Appendix C

*Tribal Agency Position
Supporting Materials*

C1 INTRODUCTION

Appendix C contains Tribal Cooperating Agencies' comments and supporting documentation that represent major differences of opinion with the analyses as presented in the SDEIS. The information was submitted by the Bois Forte, Grand Portage, Fond du Lac, Great Lakes Indian Fish & Wildlife Commission, and the 1854 Treaty Authority. All materials in this appendix are Tribal views provided verbatim and have not been validated or approved by the Co-lead Agencies.

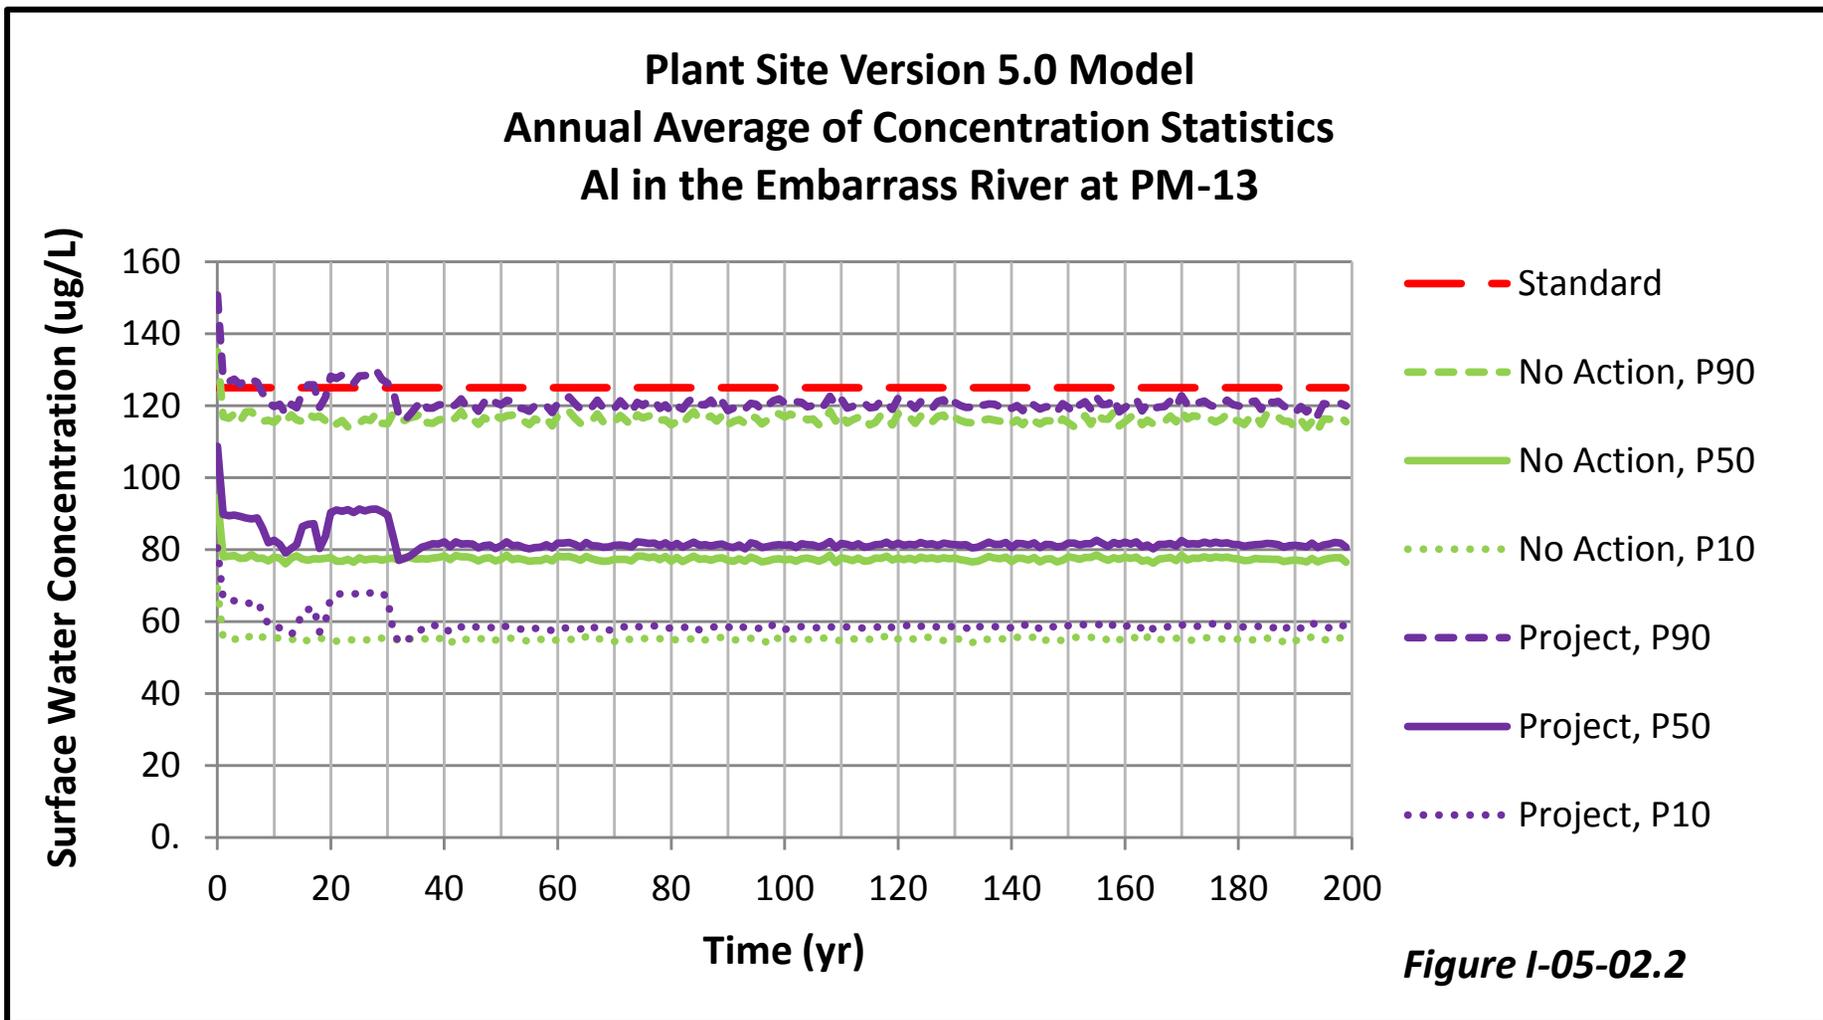
The above examples are not an exhaustive list of discrepancies between observed existing water quality data and the Goldsim P50 prediction of the No-Action alternative (continuation of existing conditions) but highlight some of the most notable discrepancies. What the discrepancies demonstrate is that the Goldsim model is a relatively poor predictor of current conditions. If a model is unable to accurately predict current conditions it is even less likely to accurately predict future Project conditions. The Goldsim models need to be better calibrated to existing conditions (the calibration effort reported in "Calibration of the Existing Natural Watershed at the Plant Site v4 MAR2012" only compared model output to upstream site PM-12 and apparently did a poor job of preparing the models to predict either the lower reaches of the Embarrass or the Partridge River.) and model results recalculated.

Figure F-01-10.1

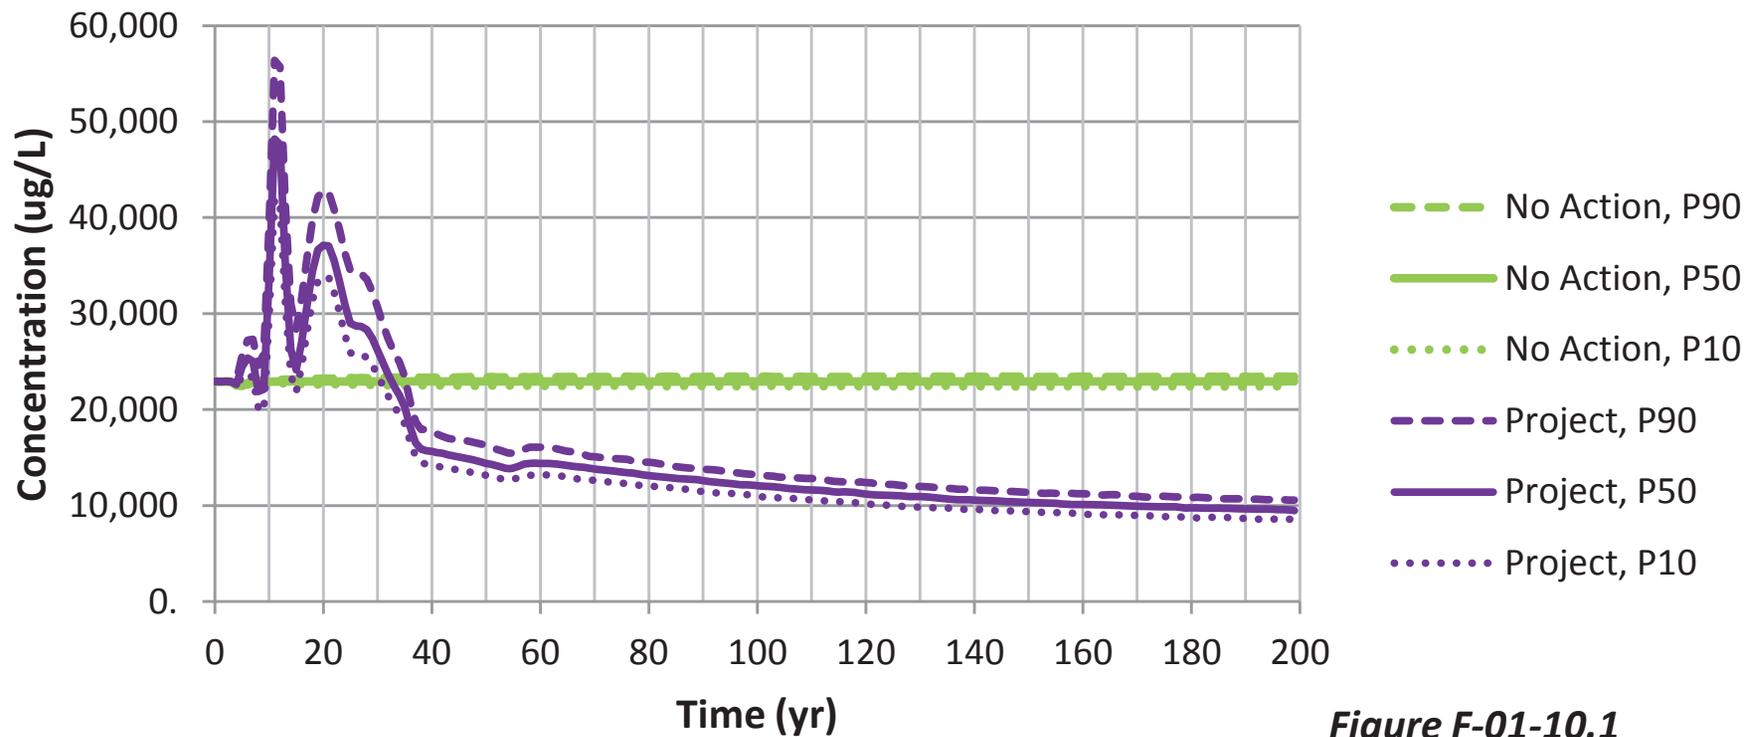
Based on the above CEQ guidelines, it is clear that activities that will occur under the Cliffs Consent Decree should be included in modeling of a No Action alternative. Unfortunately not only are the consent decree activities not included, but the fact that it will be precipitating on the tailings basins for the foreseeable future has not been included in the No Action modeling. This is evident by the model results that show stable levels of Chloride coming from the basins for the next 200 years (Figure attached) when there is no ongoing source for Chloride. With no source for new Chloride, rainwater will gradually dilute the residual Chloride in the basin and levels will drop. The PSDEIS claims that the basins water quality has stabilized and that the current conditions will not change over time. The claim of chemical stability is based on basin pond water sampling for only 4 years (2001 - 2004, PSDEIS Table 4.2.2-23).
